ADDENDUM NO. 2

North Central High School Outdoor Athletic Facilities - Phase 4a – Early Grandstand and Press Box Package
1801 East 86th Street
Indianapolis, IN 46240

JUNE 22, 2023

PREPARED BY SCHMIDT ASSOCIATES FOR:
NORTH CENTRAL HIGH SCHOOL RENOVATION
WASHINGTON TOWNSHIP, M.S.D. OF

P-3

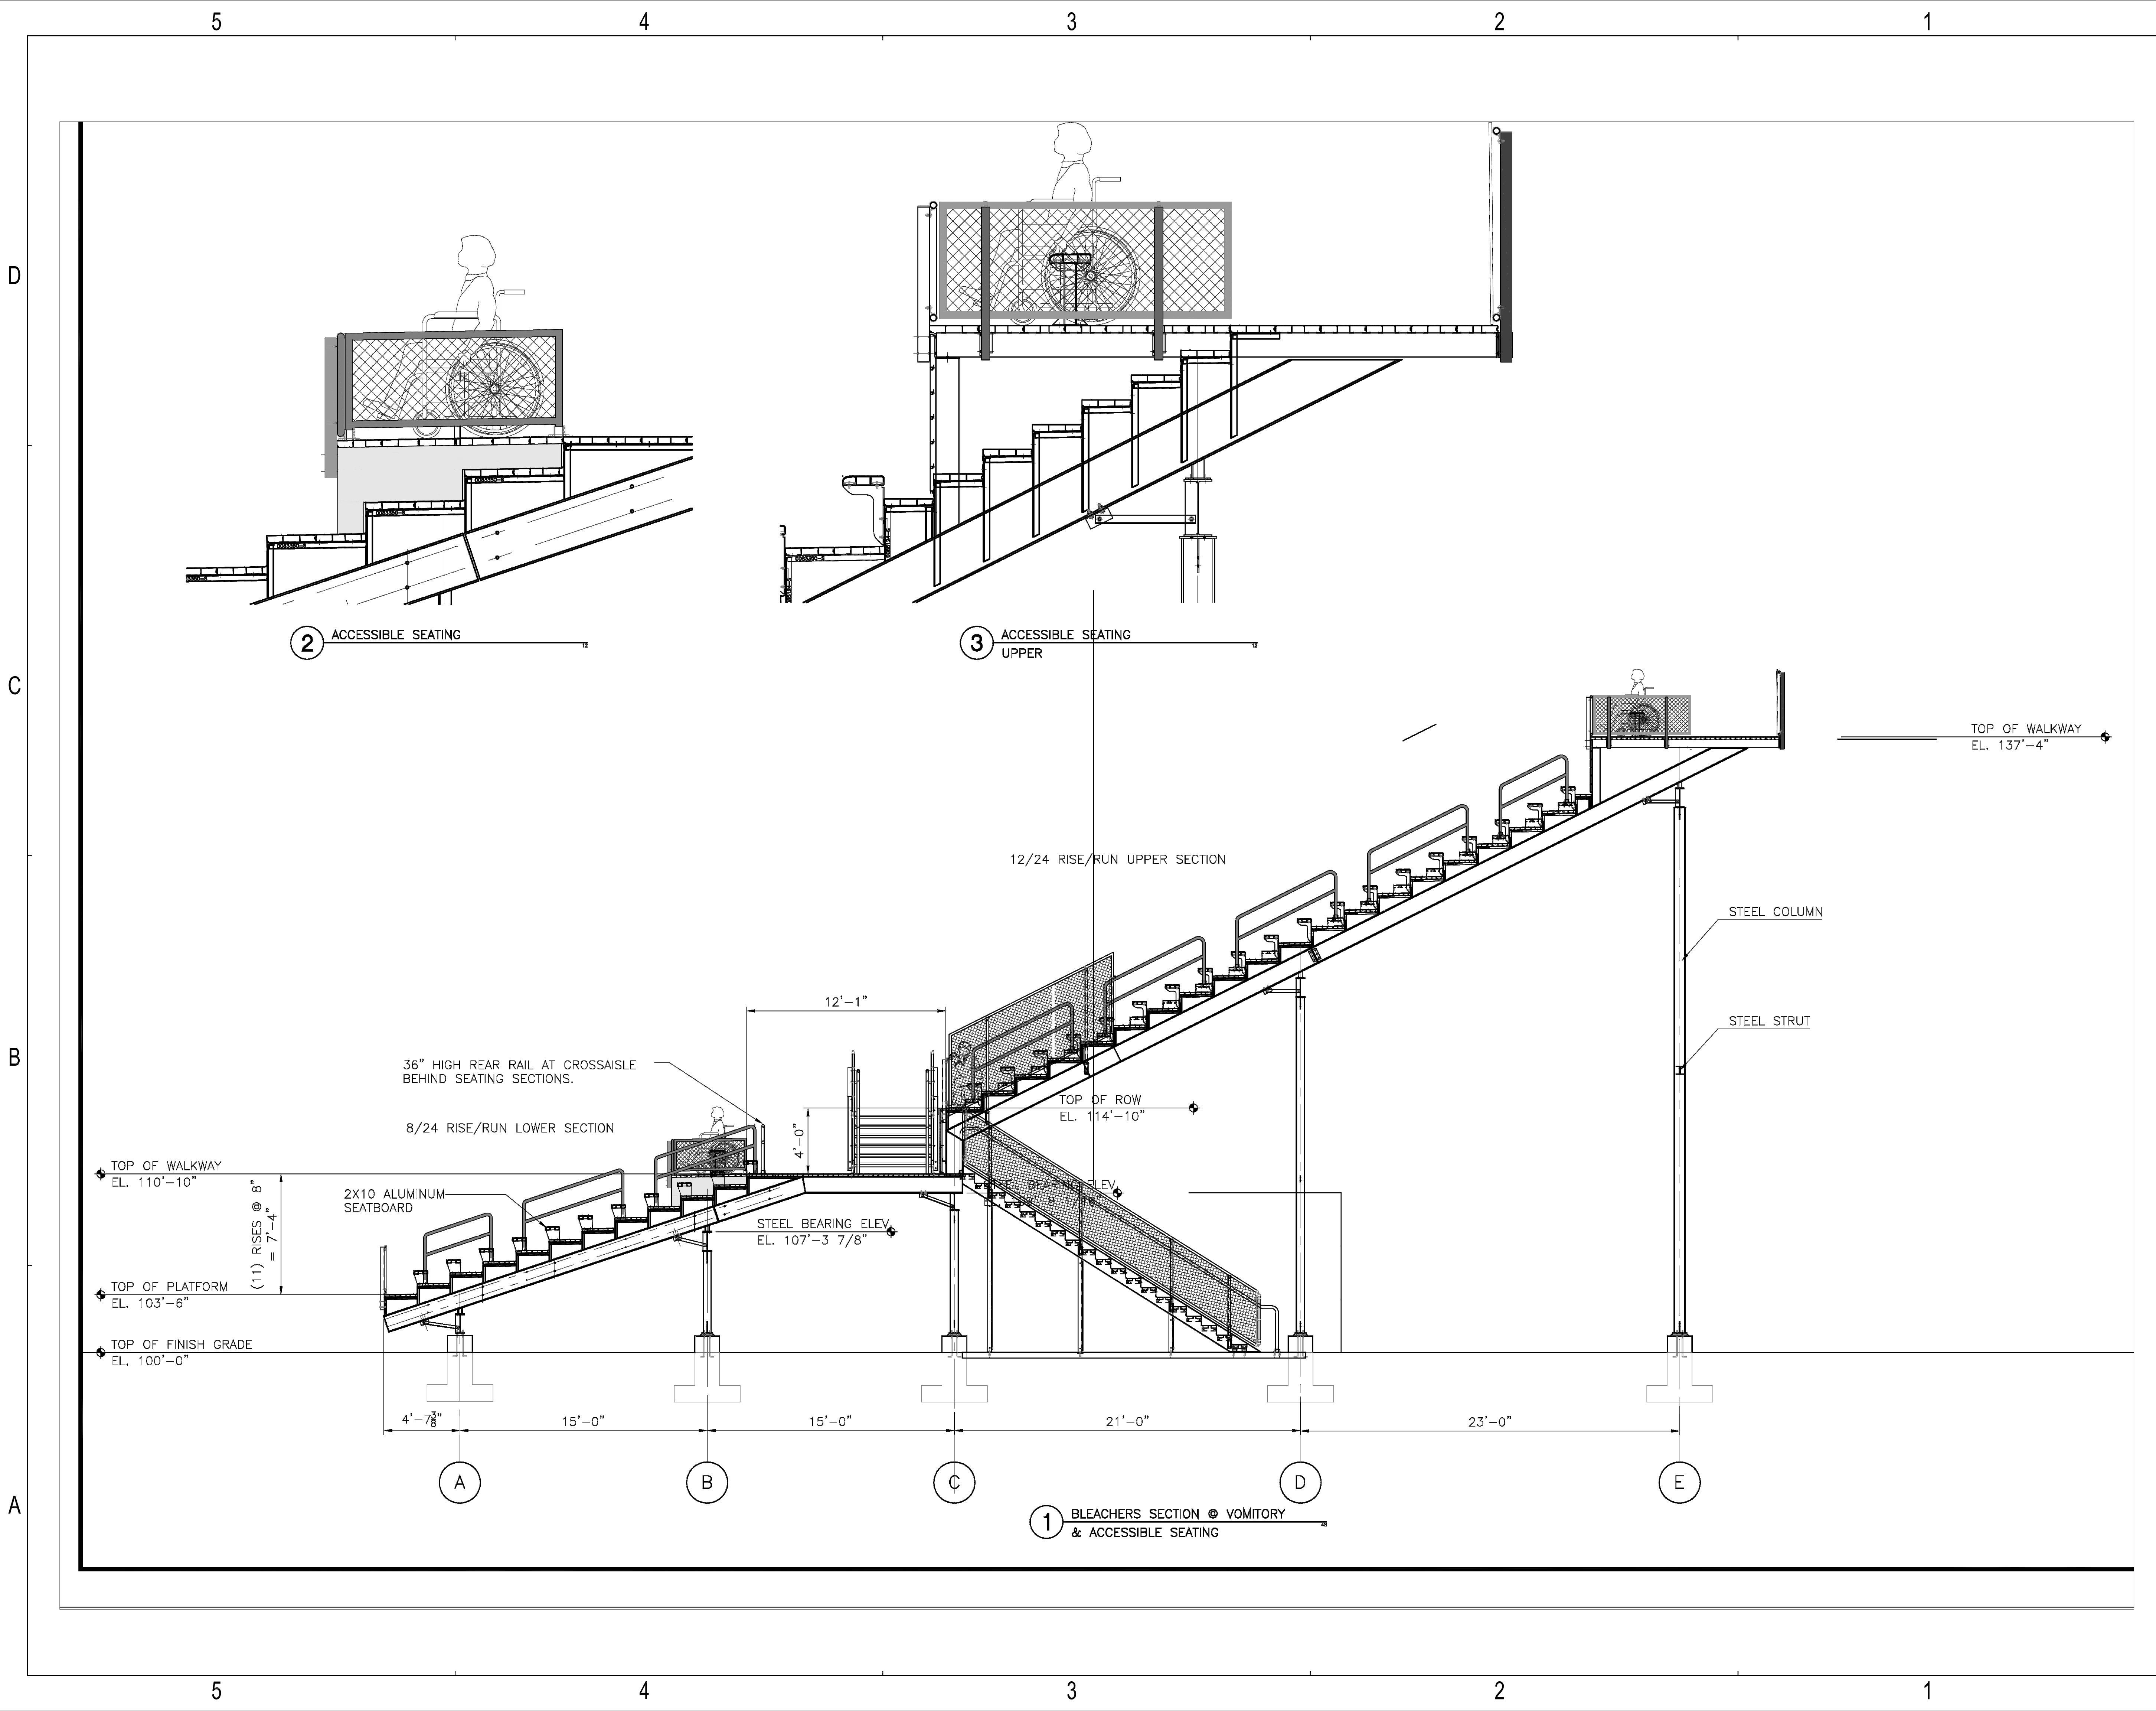
DRAWING NO.	INDICATE ACTION: ADD (A), DELETE (D), DELETE & REPLACE (R),
C-SERIES DRAWINGS	
Home Grandstands P-3	ADD

2. There are no section drawings for the home bleacher. Will any be provided?

4. Can a section thru the Home Side grandstand be provided? If not, what is the elevation of the front tread of the grandstand with respect to grade?

SEE ADDENDUM 2

SEE ADDENDUM 2
